AMENDMENT OF SOLICITATION/MODIFICATION OF CONTRACT

2. AMENDMENT/MODIFICATION NO.	3. EFFECTIVE DATE	4. REQUISITION/PURCHASE REQ. NO.	5. PROJECT NO. *(If applicable)*
0002	09/09/2004		AZ-NV HPP 93(3)

9A. AMENDMENT OF SOLICITATION NO.
AZ-NV HPP 93(3), Hoover Dam Colorado River Bridge

SF30 CONTINUATION SHEET Item 14 Description of Amendment/Modification
AMENDMENT #2

DETAIL 1 1.45 1 –

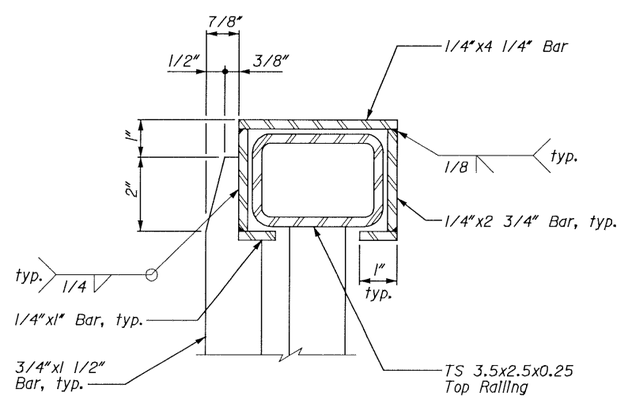
Remove Sheet 304 and replace with new Sheet 304. Added Notes designated by revision symbol Î.

⚠ Notes:

1. Top Railing shown, Bottom Railing similar.
2. Provide 1/2" diameter drilled hole centered at low end of bottom Fabricated Railing Sleeve.

6. Contractor to submit complete shop drawings showing all details of the pedestrian railing for review by the CO.
7. ⚠ Top and bottom tube rails (TS 3.5x2.5) to have 1/8" end plates with seal welds at all expansion joints (abutments and intermediate locations).
